ARCHITECT'S ADDENDUM

Addendum Number: 003

RE: EASD #131 East Aurora High School
2027 Mechanical Improvements

Subject: Addendum No. 003 to the Construction Documents for the EASD #131 East Aurora High School 2027 Mechanical Improvements Project.

1 ELECTRICAL LIGHTING PLAN - TUNNEL
1/32" = 1'-0"

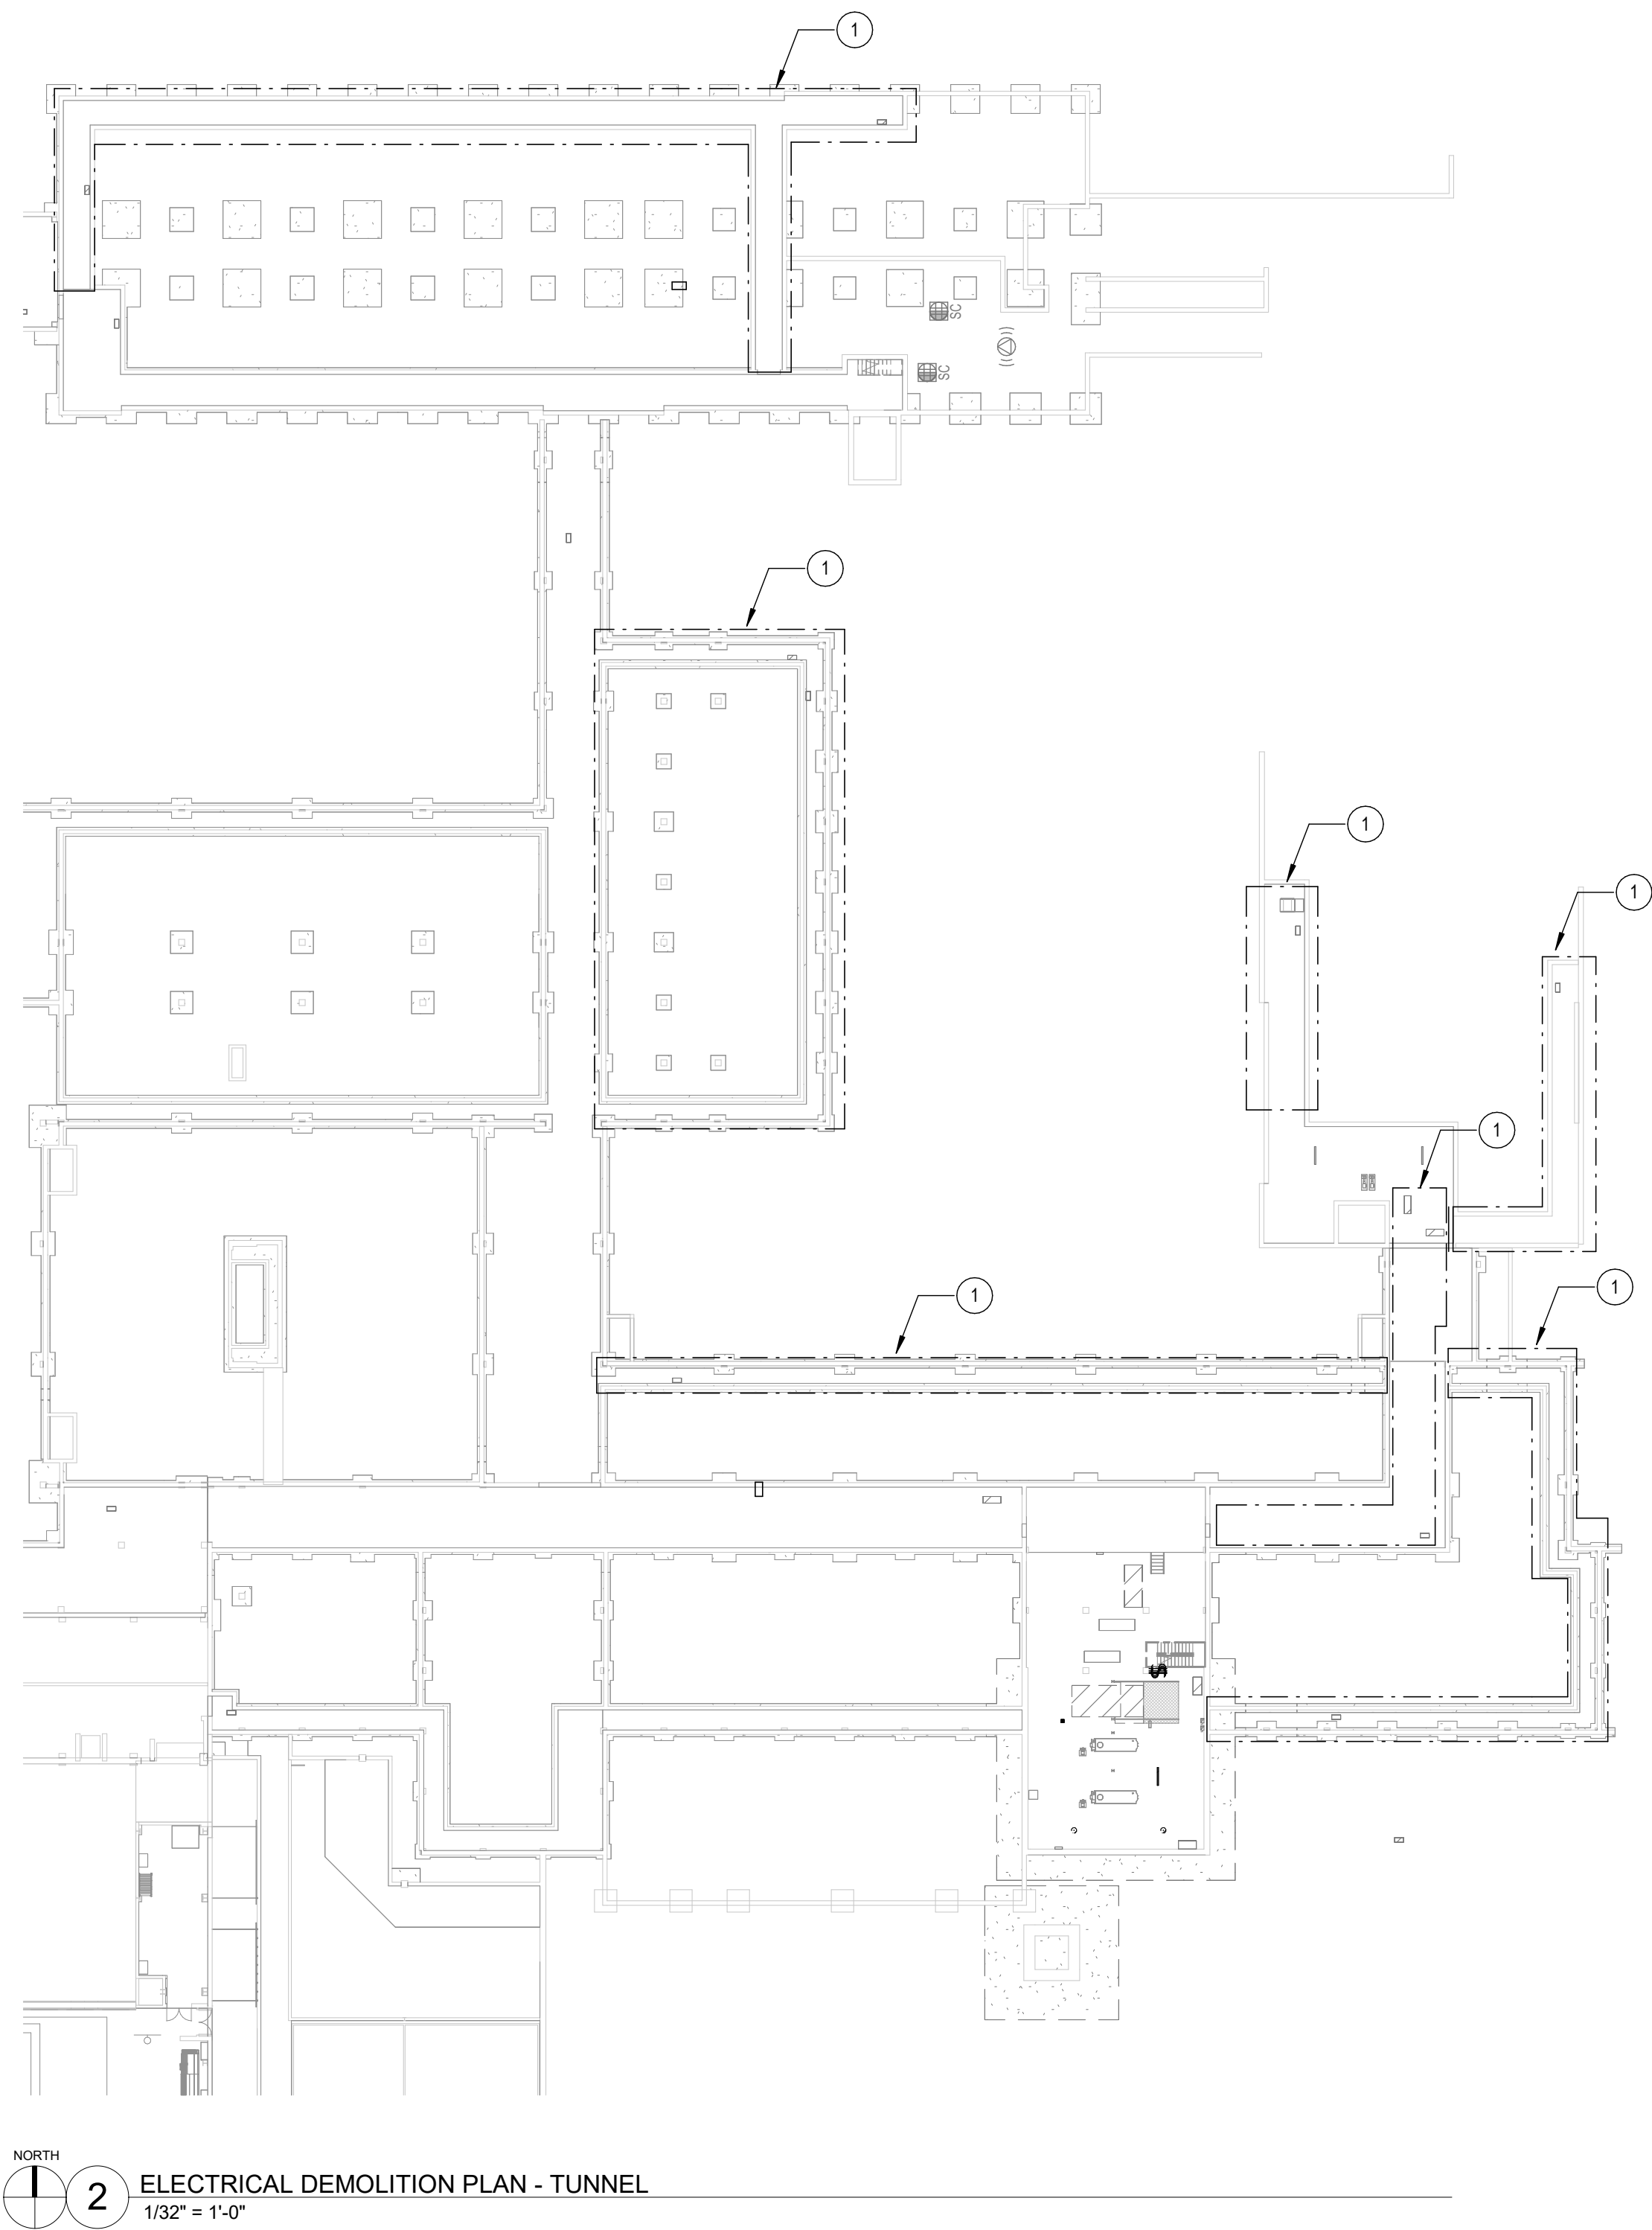
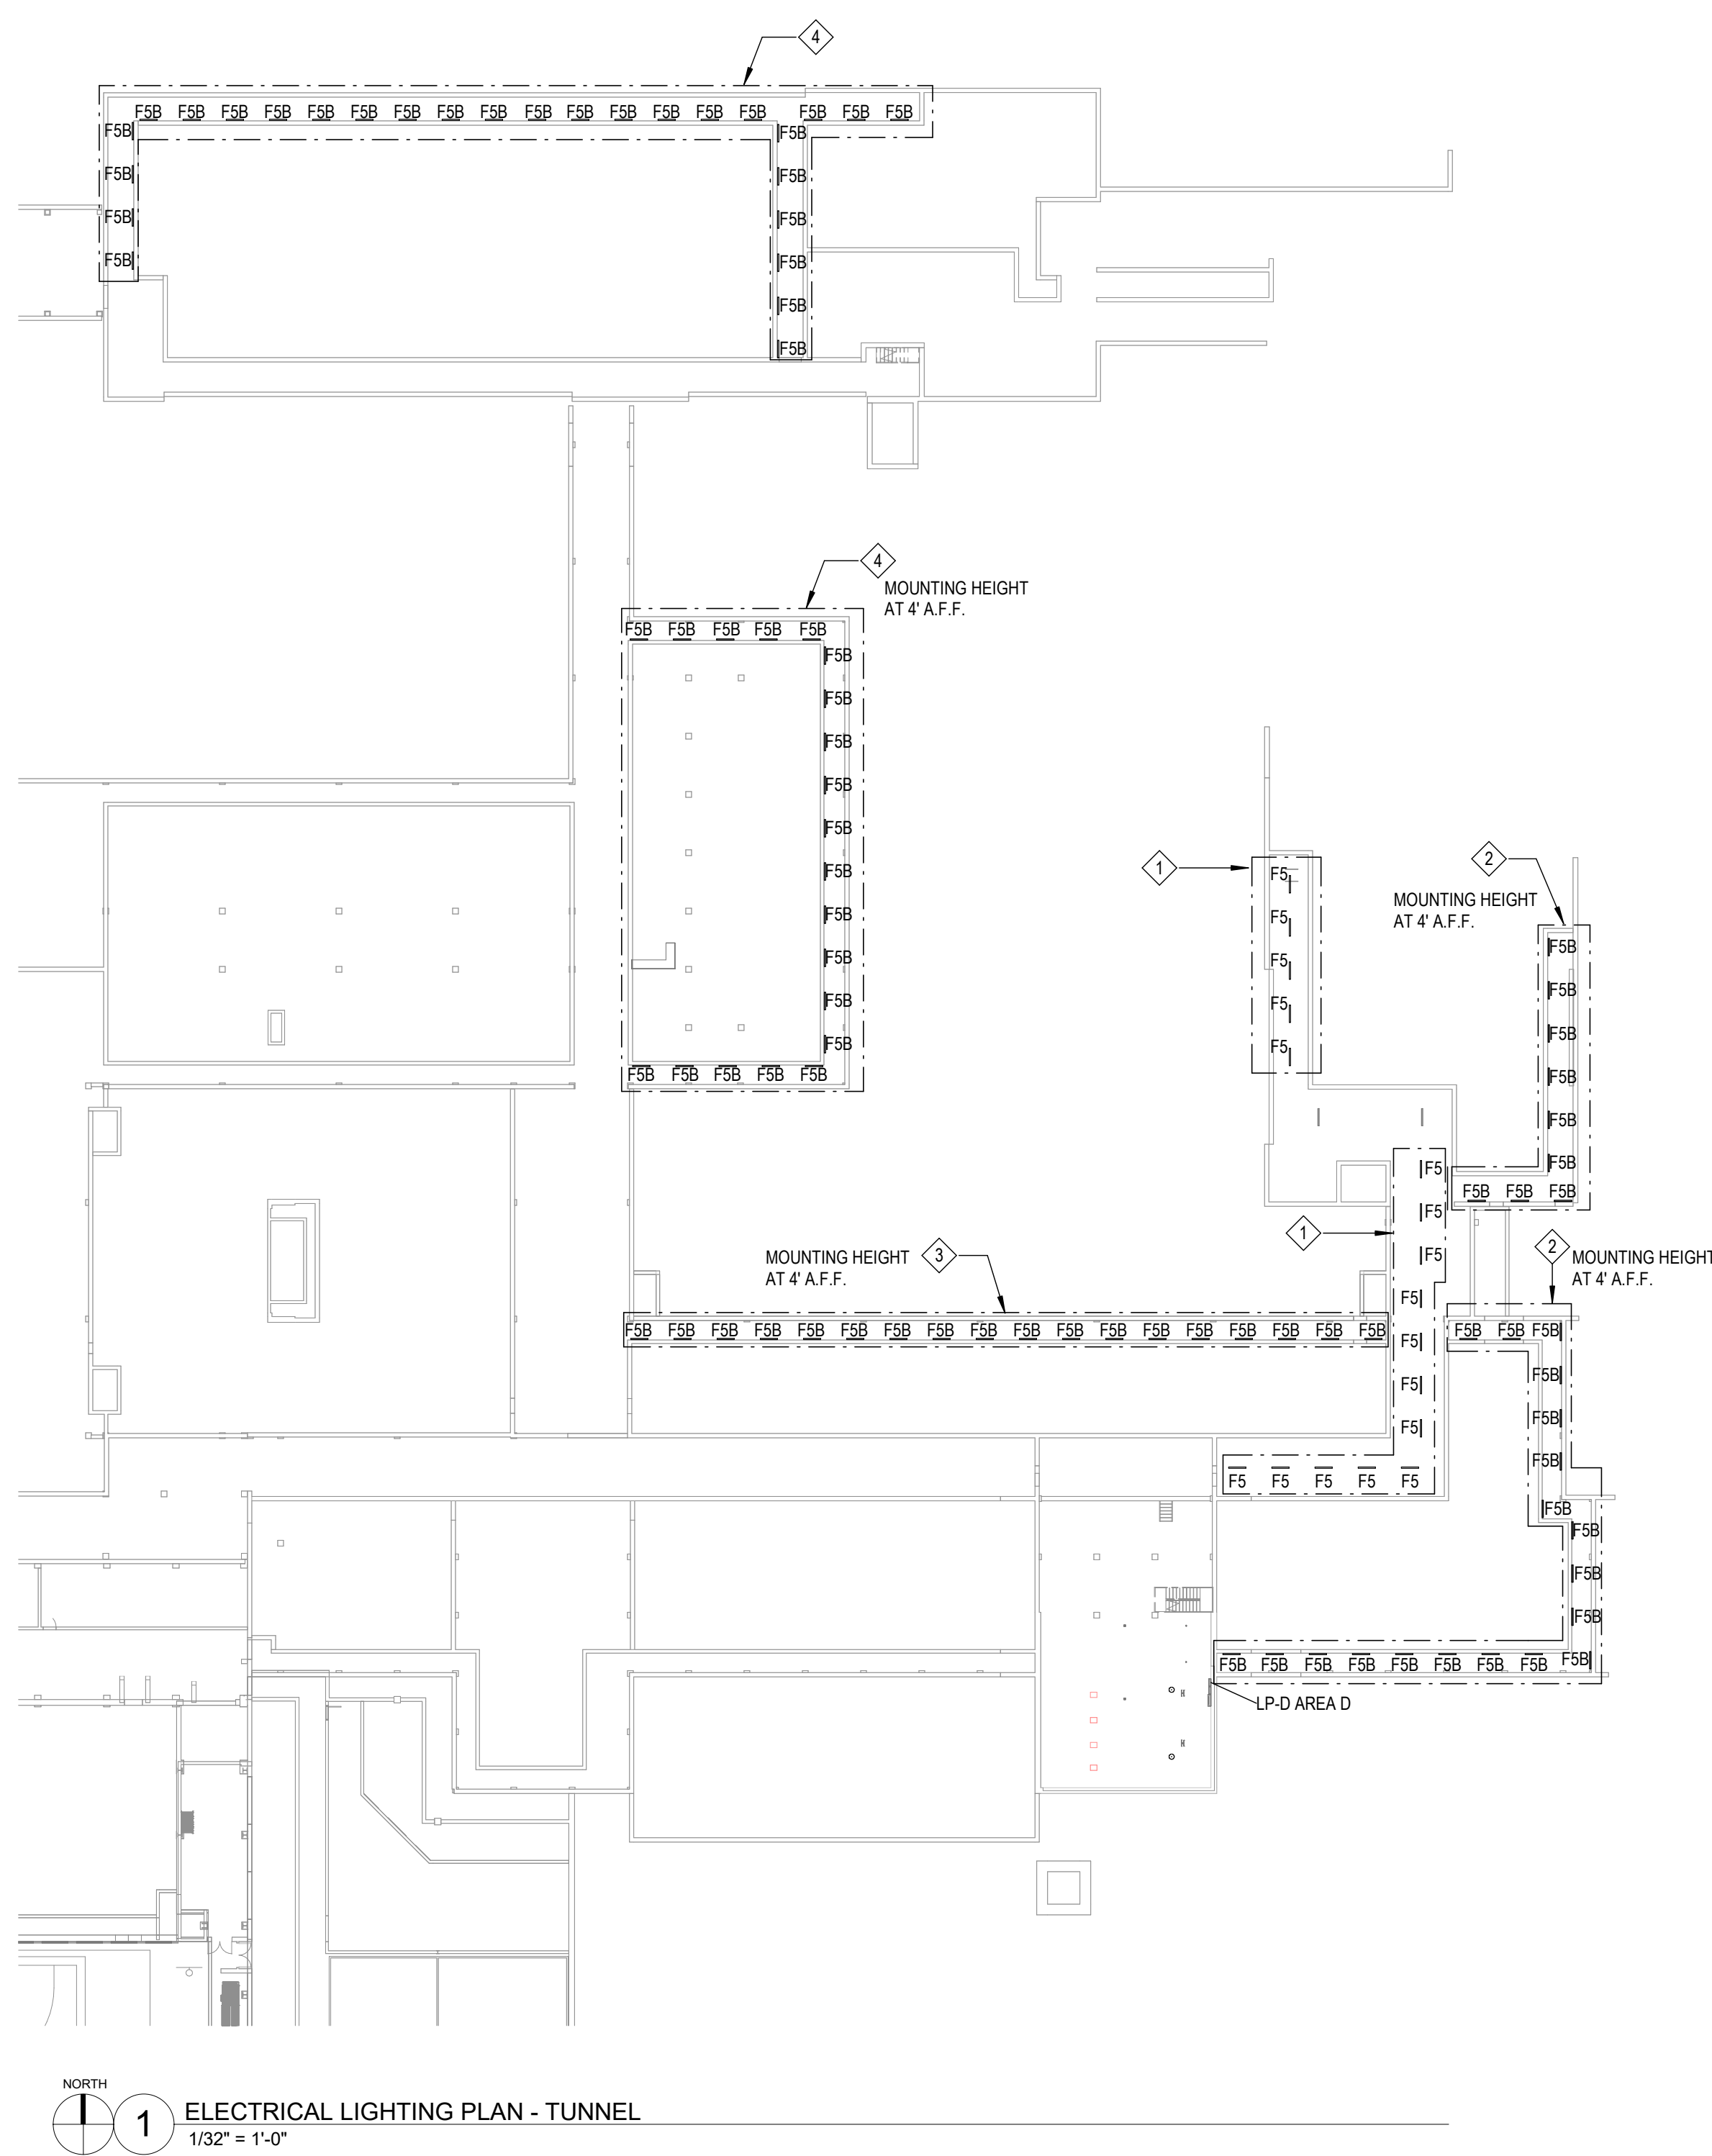
7. E5.1 – OVERALL TUNNEL PLAN – LIGHTING PLAN

- **REVISED** drawing notes to indicate that all work shown on this sheet is included in Alternate #08.
